CR152 Replacement of number plate holder subframe vibration dampers

Models: Panigale V4 2018 (all model versions)

Technical Service Bulletin SRV-TSB-18-007

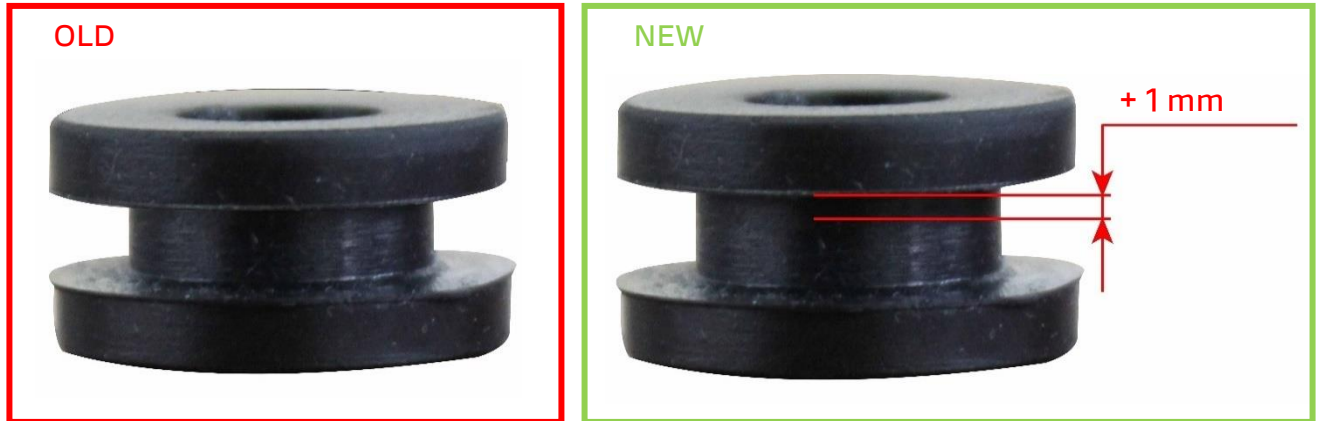
6) Take the 2 new vibration dampers Part no.76412501A.

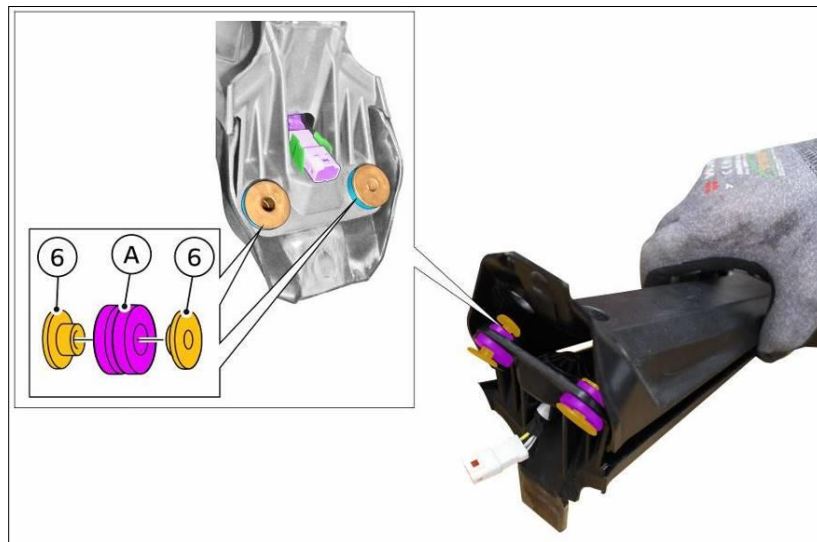
7) Install the 2 new **vibration dampers (A)** inside the holes of the upper number plate support and insert the **4 upper and lower spacers (6)** with collar as shown in the figure.
